Appln. No.: 10/522,044
Amendment Dated April 12, 2007
Reply to Office Action of January 24, 2007

Amendments to the Drawings:

Remarks/Arguments:

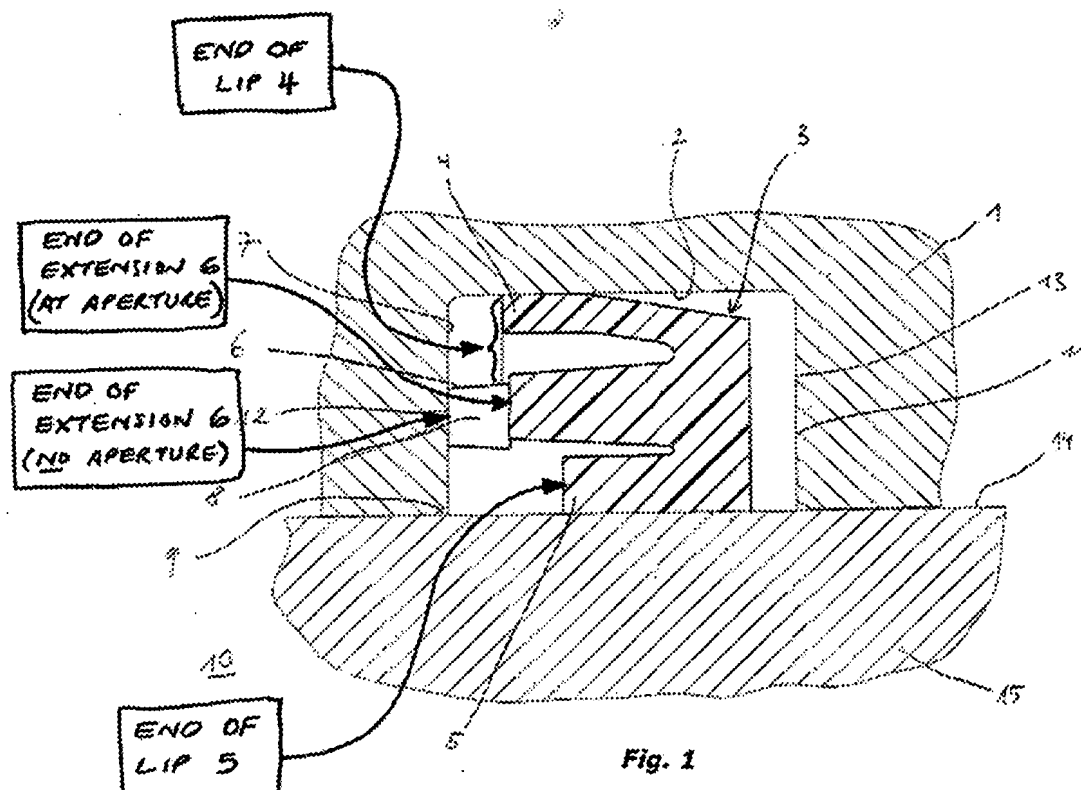
Figure 1 is objected to based on an apparent misunderstanding of the three-dimensional view and circular geometry depicted in the drawing. Applicant respectfully submits that the features are clear and should require no additional explanation. To further prosecution, Applicant has amended the specification and drawing to identify the vertical extension line extending from circumferential lip 4, which represents the free end of the lip visible behind the plane where the section is taken. For added explanation, Applicant is reproducing the prior version of Figure 1 with appropriate labeling below:

Q: "It is unclear as to how 8 corresponds to the extension because it is off center."

Q: "It is also unclear as to where the extension ends because the aperture labeled as 8 is off-centered from the extension"

Q: It is also unclear as to what the extra line connecting the outside lip 4 and the aperture 8 in Fig. 1 is for, the line must be identified . . . or the line must be removed

The Office Action finds that it is unclear whether there is a circular geometry depicted for extension 6 in Fig. 1.

Please replace the drawing sheet containing Fig. 1 with the attached replacement drawing sheet (now Sheet 1 of 1).

The above figure identifies the free ends of the lips 4, 5 and the free end of the extension 6. The free ends of lips 4, 5 are labeled 40 and 50, respectively, in the corrected drawing sheet. Free end 12 of extension 6 is already labeled. Note that free end 12 of extension 6 does not contact the groove wall 7 in the cross-sectional plane, because of the aperture. In planes beyond the cross-section, the aperture ends, and free end 12 becomes contiguous with groove wall 7.

A: Reference number 8 refers to the aperture, not the extension 6 (see specification).

A: The location of the free end of the extension 6 depends on the cross-section. At sections containing an aperture, the extension 6 ends short of the groove wall 7. At sections that do not contain an aperture, the extension 6 ends contiguous with the groove wall 7. The aperture is not "off-centered" from the extension. The aspect that appears to be off-centered is a plane where the groove ends. Sealing collar 3 has a circular geometry, and the extension 6 and lips 4, 5 turn through a radius to follow the circular geometry. Therefore, one skilled in the art who views the sealing collar in cross section will expect there to be some angular offset in the drawing to show the cross-sectional plane, and other planes that are visible beyond the cross-sectional plane. The plane where the aperture 8 ends is not "off-centered", but rather angularly offset from the plane through the cross-section. The staggered shape represents the plane where the aperture ends, and where the non-apertured portion of extension 6 begins.

A: The line that appears to connect lip 4 and extension 6 represents the free end of lip 4. This free end is now labeled in the drawing and described in the specification as free end 40. It is shown as an "extension line" to reflect that the free end 40 makes a continuous turn as it extends in a circular manner. Omitting this line would be misleading because the lip 4 would no longer be depicted as a circumferential lip that extends continuously through the radius.
